5DX-71-S

# SERVICE NOTE

## 5DX Series 3 and Series 5000 Systems

#### POSSIBLE SHOCK HAZARD

Figure 1: Identification of the Power Adapter (Model No. D12-1A-950)

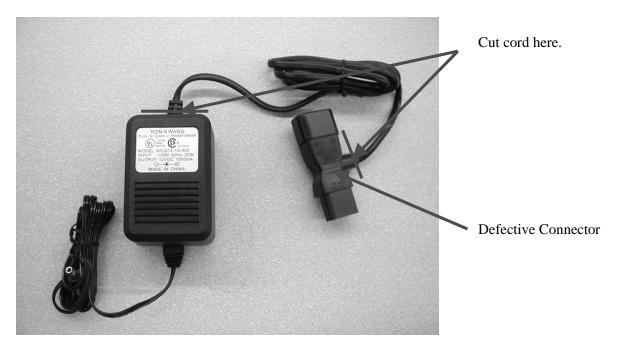
To eliminate the possibility of a safety hazard developing should this power adapter be used in any other application, this power adapter must be destroyed and discarded immediately. To destroy the adapter, cut the cord connecting the power connector to the actual adapter. Dispose of the adapter. Please see the Figure 1 for clarification.
